Metropolitan Historic Zoning Commission
Sunnyside in Sevier Park
3000 Granny White Pike
Nashville, Tennessee 37204
Telephone: (615) 862-7970
Fax: (615) 862-7974

STAFF RECOMMENDATION
202 Mockingbird Road
October 18, 2017

Application: New construction - addition
District: Cherokee Park Neighborhood Conservation Zoning Overlay
Council District: 24
Map and Parcel Number: 10312016401
Applicant: Betsy Bergin
Project Lead: Sean Alexander, sean.alexander@nashville.gov

FRONT ELEVATION

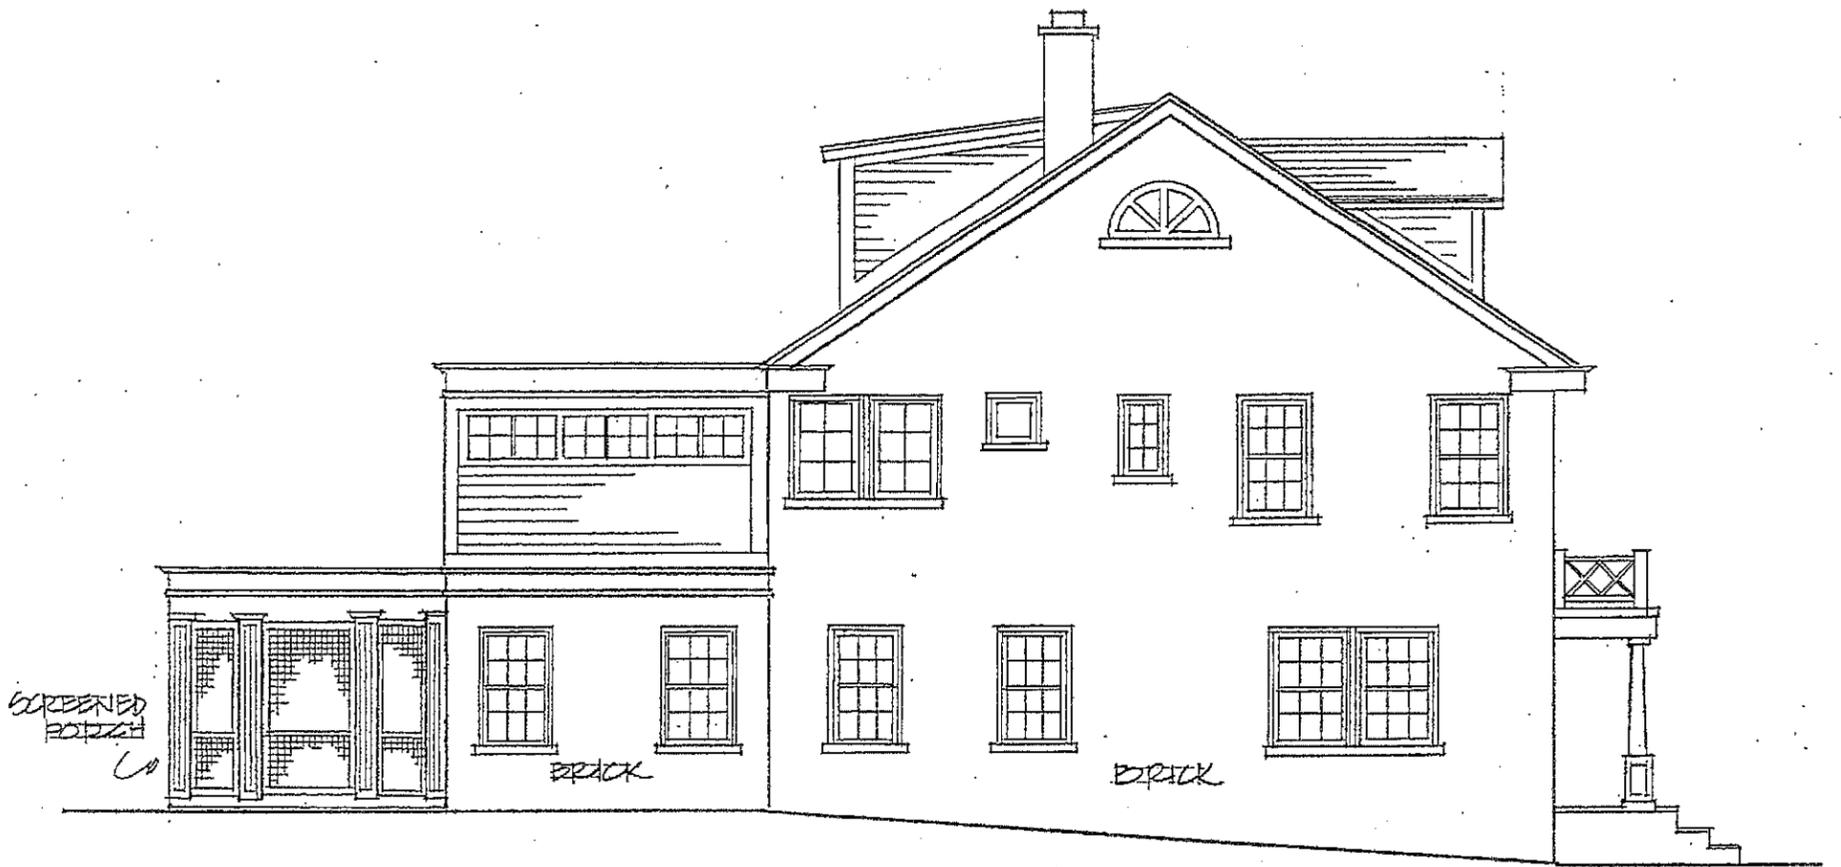
Location & Removability: The proposal would alter the roofs of two existing dormers, replacing their shed roofs with front-facing gables. The location, height, width and window configuration of the dormers would not change. Removal or alteration of historic features is generally not appropriate, however these dormers appear to have been altered from their original form. Shed-dormers are not typical features on side-gabled Colonial Revival houses, and in fact there is physical evidence that the shed roofs are not original. While the primary roof framing and decking is original, the rafters in the dormers have clearly been reframed with newer modern lumber.

Because the dormer roofs are not original and the alteration will be more appropriate for the building than the existing shed roofs, staff finds that the alteration to front-facing gables is appropriate.

The proposal would also add a Classical portico at the front entry, ten feet, four inches (10'-4") wide and four feet (4') deep, to the front of the house, replacing the existing entry design. Front entries are considered a character defining feature of historic buildings. The portico will be eleven feet (11') tall including a two foot, six inch (2'-6") tall balcony rail. While this type of feature is not uncommon for Colonial Revival houses, there is no indication that this house had such a feature historically. Reconstructing a missing architectural element based on physical or photographic evidence would be appropriate, but adding one is not. Adding conjectural features would also conflict with the Secretary of the Interior's Standards for the Treatment of Historic Properties, upon which the overlay design guidelines are based as required by state law. Staff therefore finds that adding the portico would not meet sections II.B.2.a and II.B.2.e of the design guidelines.

Roof Form: The gables on the dormer roofs will have an 11:12 pitch, which is typical of this type of dormers on historic houses.

Staff finds that the roofs meet section II.B.1.e of the design guidelines.

Recommendation: Staff recommends approval of the application to alter the roofs of the two existing dormers, finding that the proposal meets the Design Guidelines for the Cherokee Park Neighborhood Conservation Zoning Overlay.

Staff recommends disapproval of the front portico addition and alteration of the front door, finding that it does not meet the Design Guidelines for the Cherokee Park Neighborhood Conservation Zoning Overlay.
